ADDENDUM NO. 4  
TO THE  
DRAWINGS AND PROJECT MANUAL  
FOR  
**NEW OPPORTUNITY AWARENESS CENTER  
KATY INDEPENDENT SCHOOL DISTRICT  
KATY, TEXAS**

06/17/2026

#### CIVIL CONSULTANT, ADDENDUM No. 4

P2.11

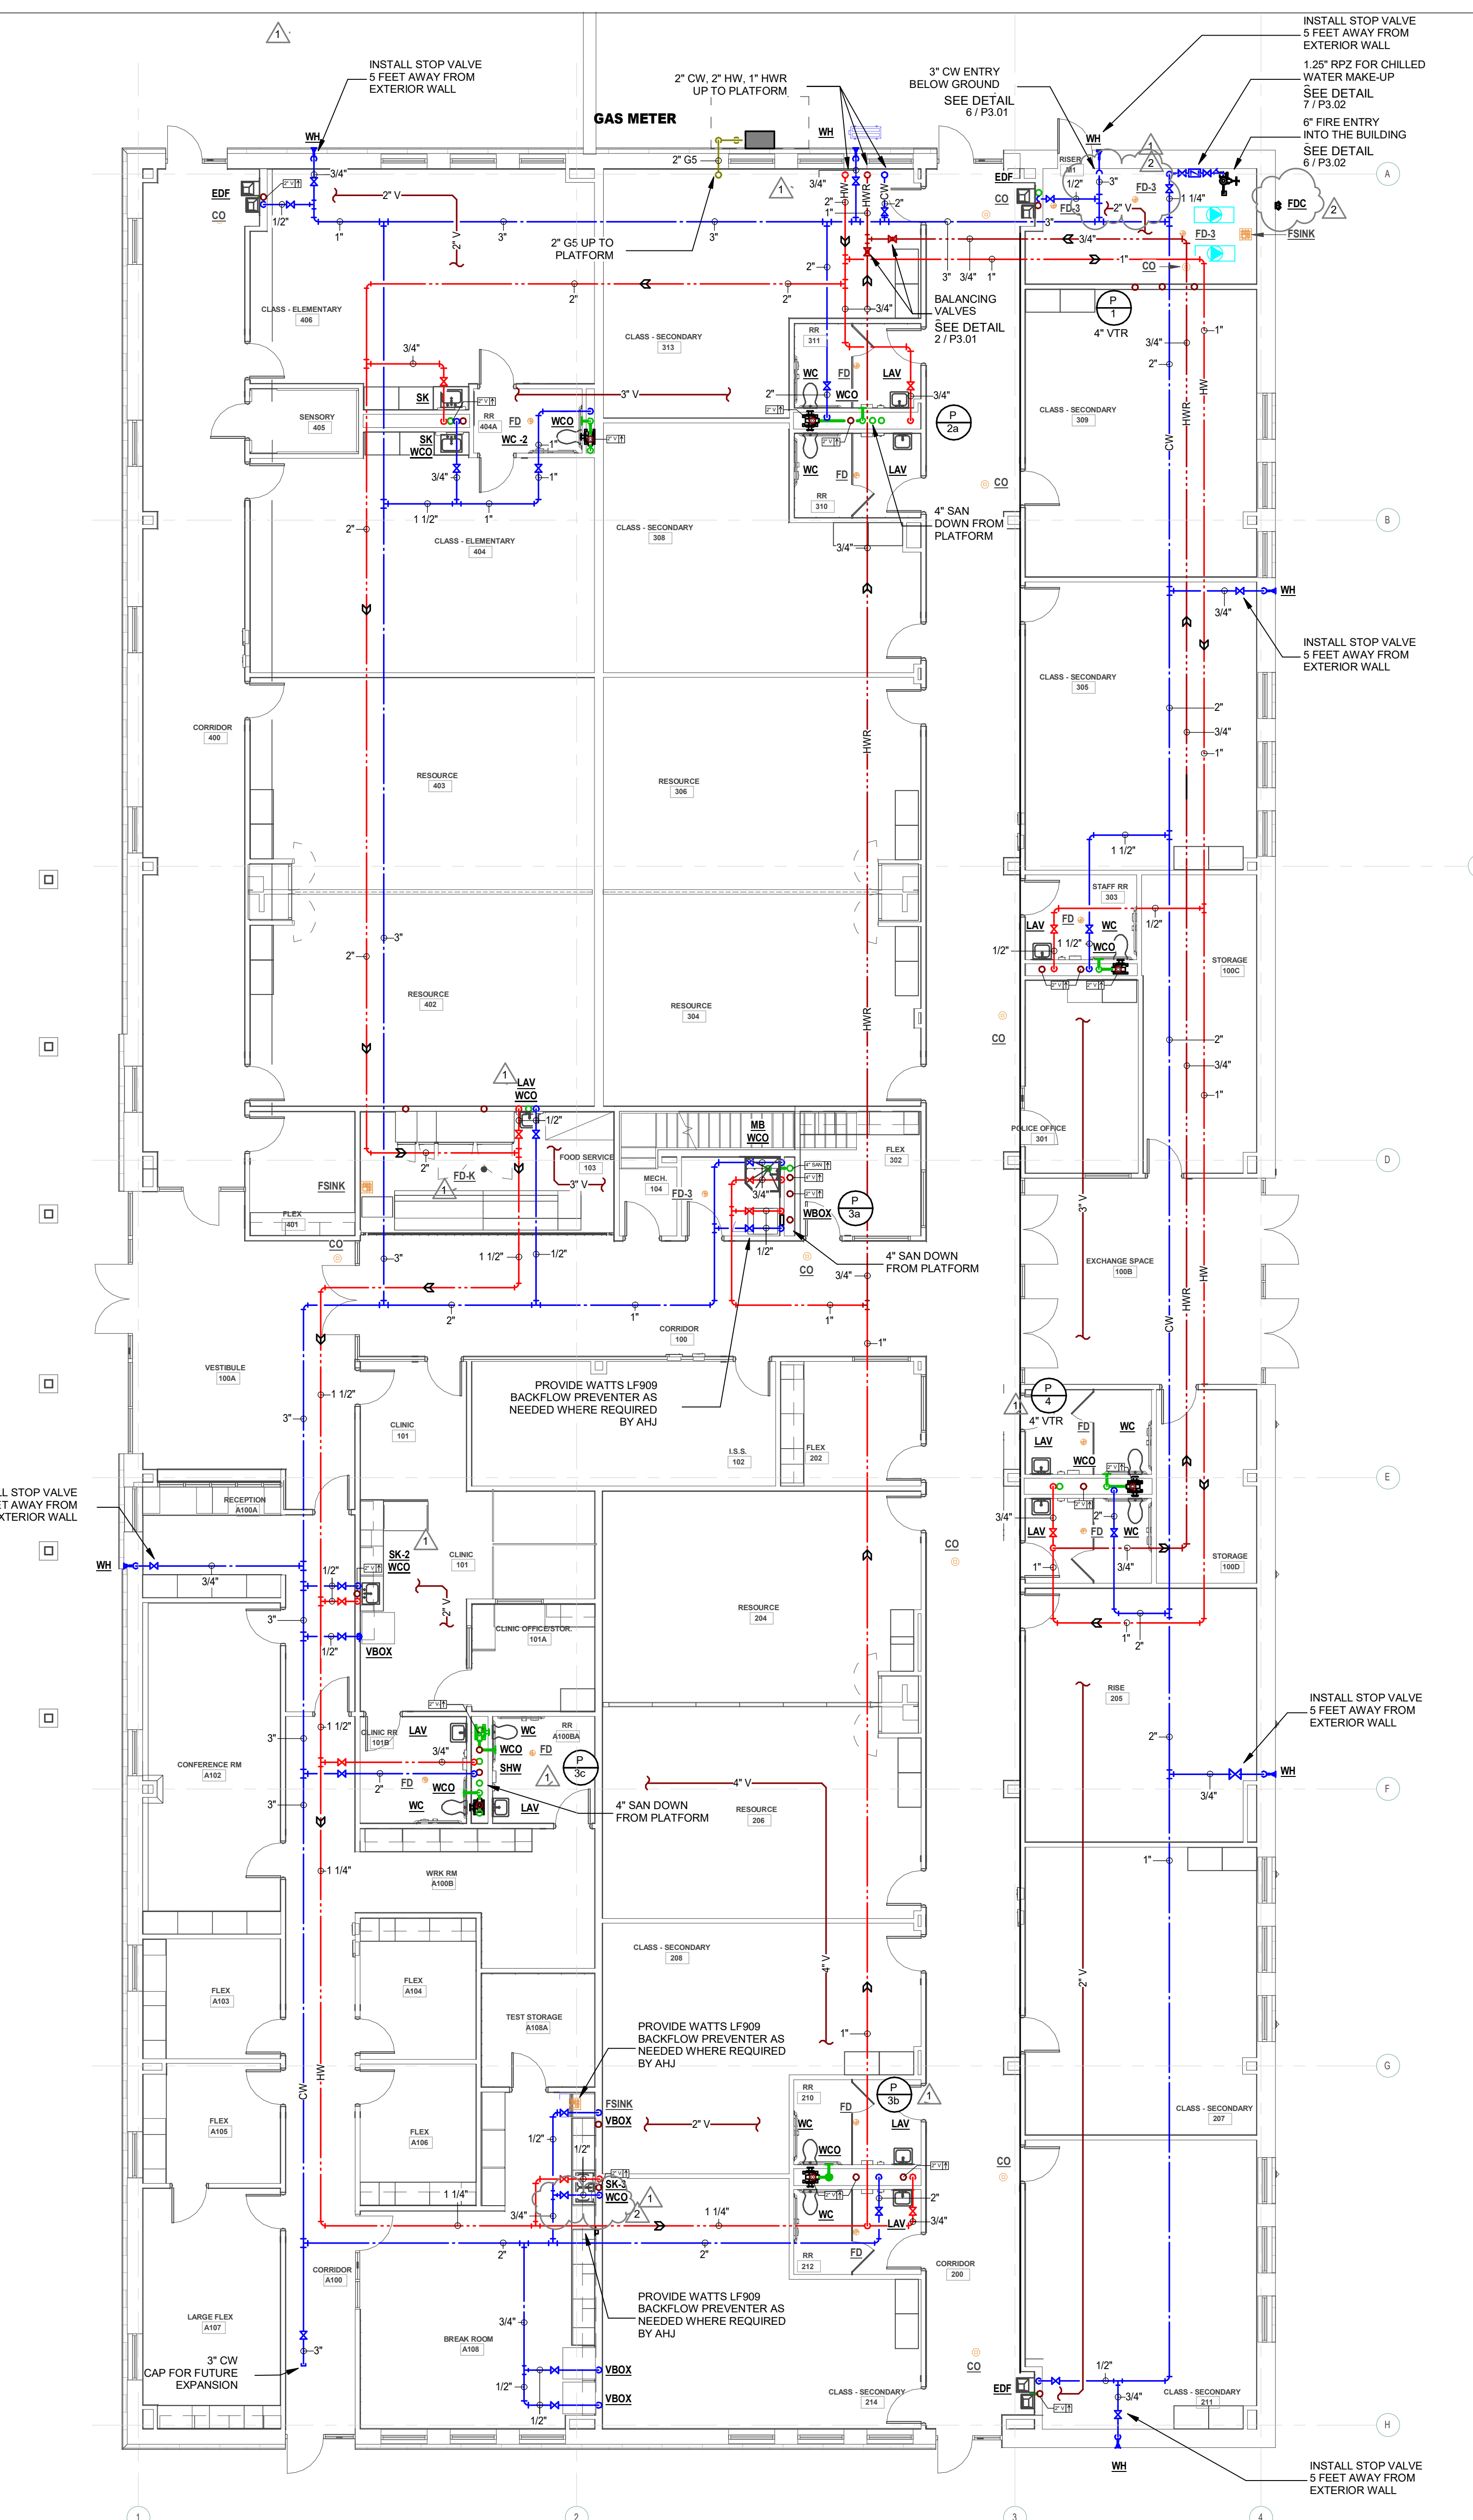
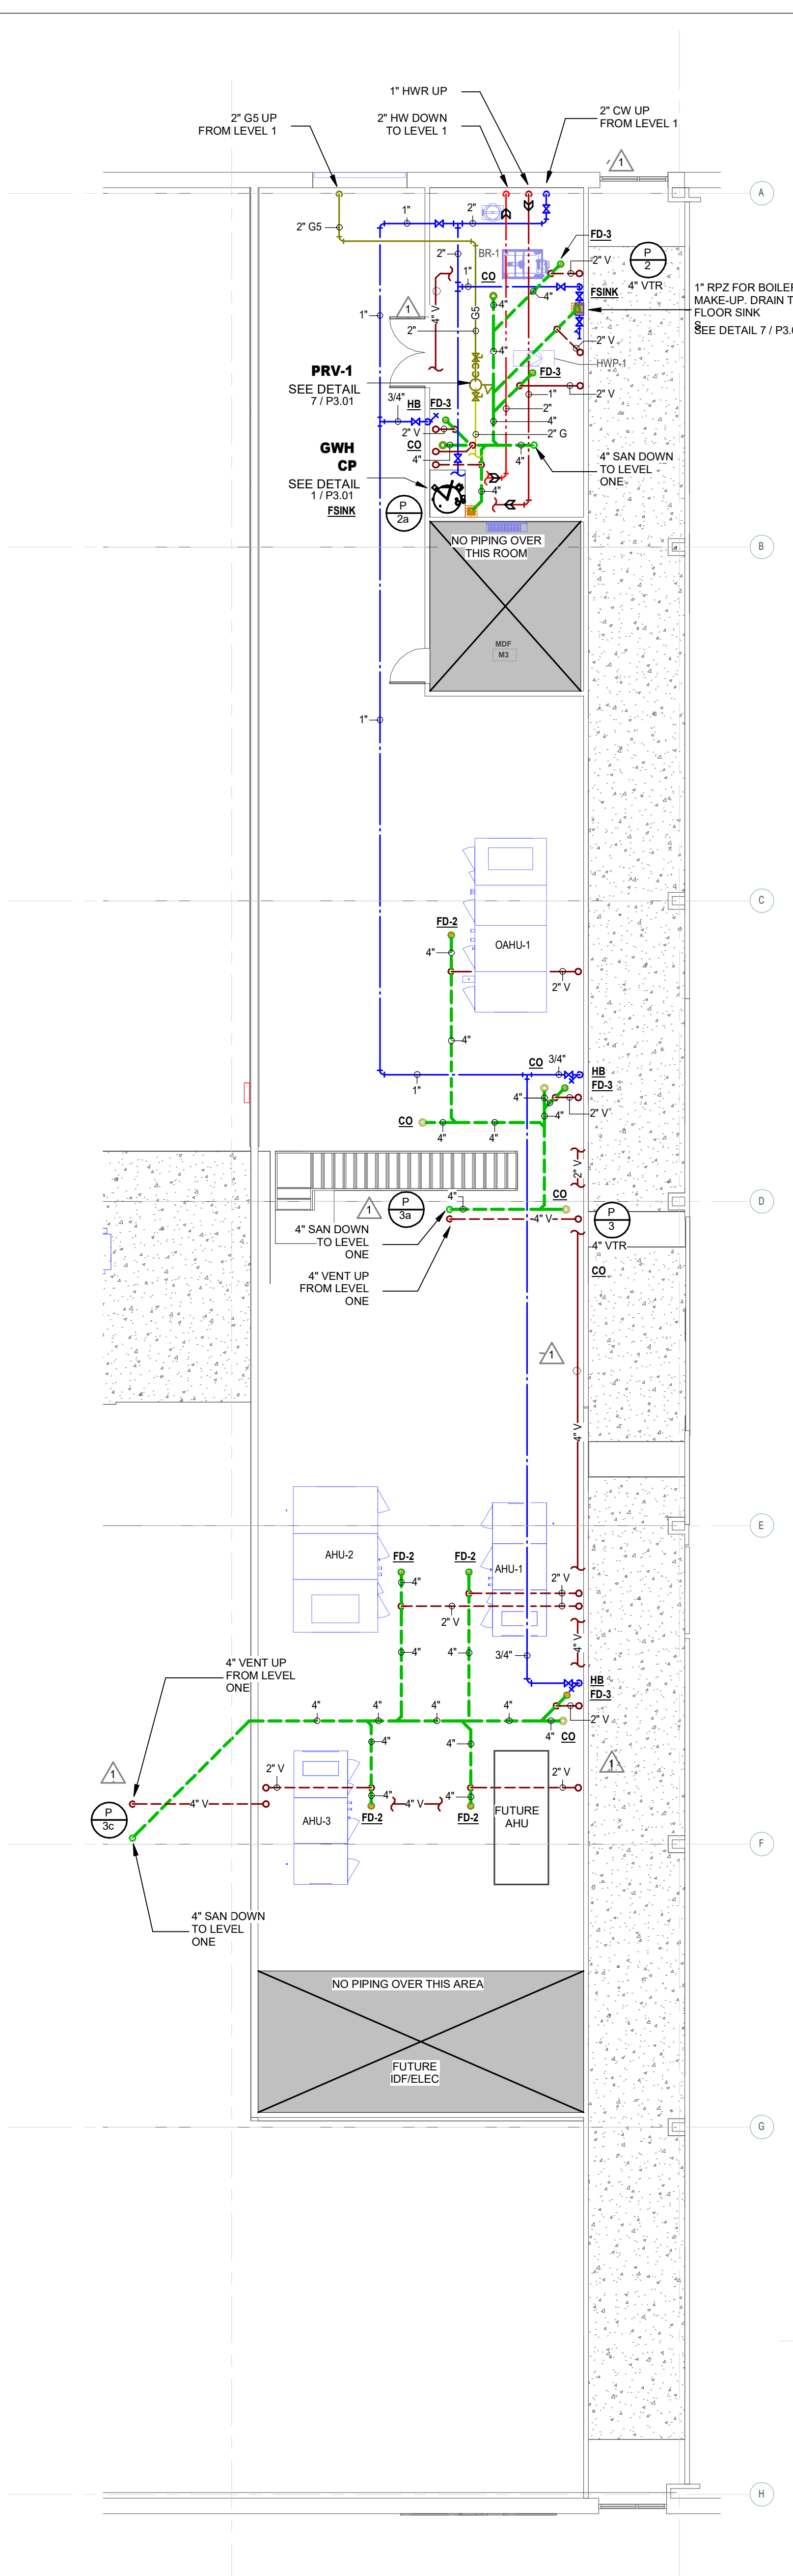
**10. SHEET P2.11 — PLUMBING LEVEL ONE FLOOR PLAN**

- A. In breakroom A108, removed the water line serving the dishwasher, it will be served from the sink.
- B. Removed the domestic water entry PRZ from the plumbing scope. Civil has it shown on their drawings. Refer to the Civil drawings for the domestic water backflow preventer location and installation.
- C. On the plumbing alternate plan for the pump room, revised the fire service double check assembly to be installed in the vertical orientation.
- D. Shifted FDC to the east wall of the riser room
- E. Added PIV to the east wall of the riser room

**6 SPRINKLER SYSTEM ENTRY RISER**  
NO SCALE

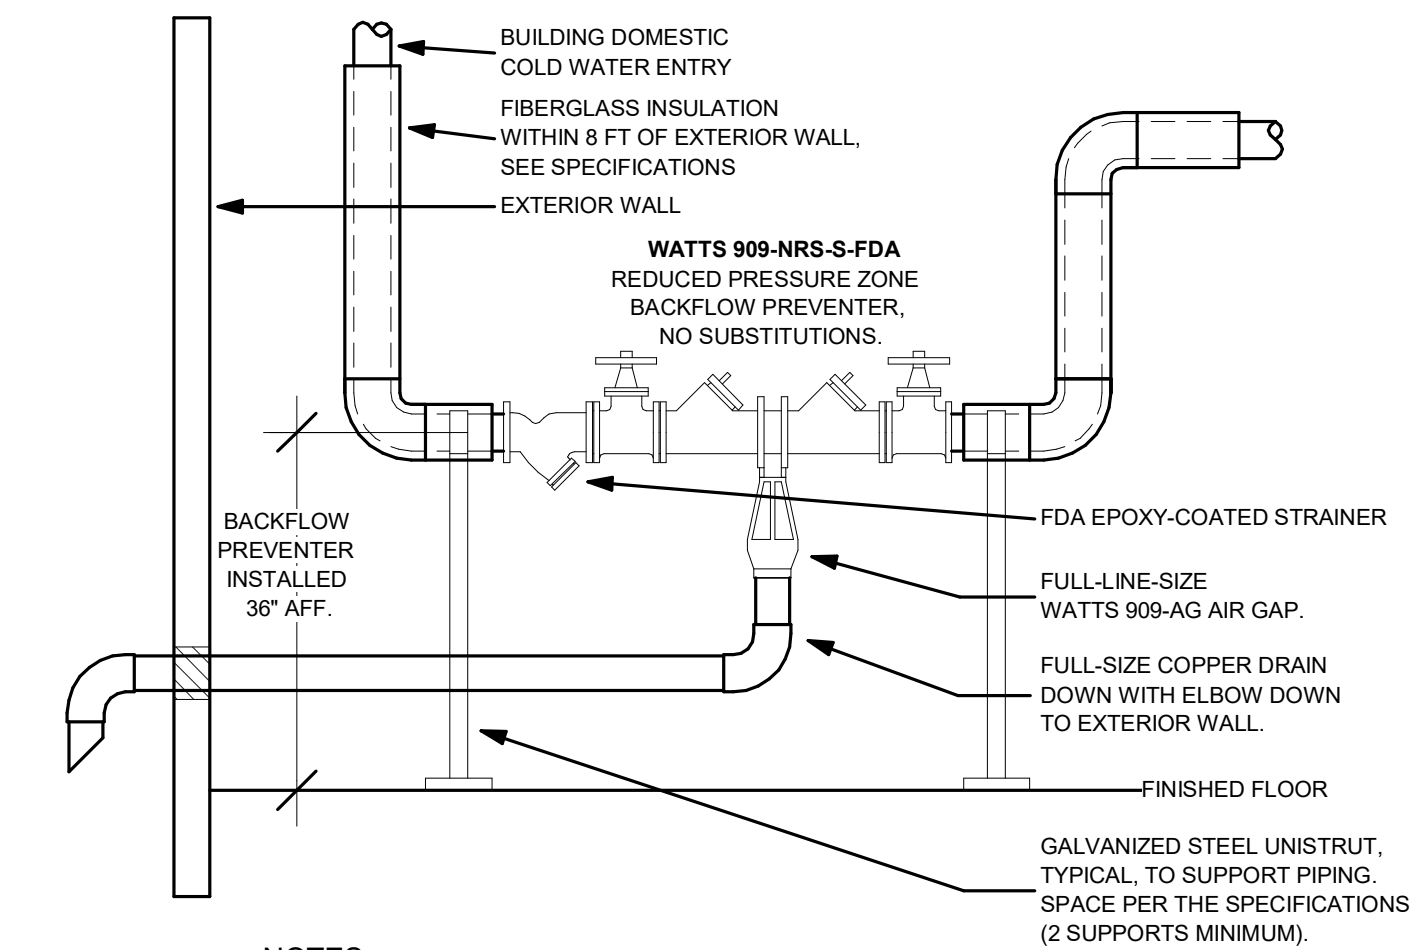
**12. SHEET P3.02 — PLUMBING SCHEDULES AND DETAILS**

- A. Updated fire sprinkler system detail to include the PIV and the vertical double check valve for the fire entry.
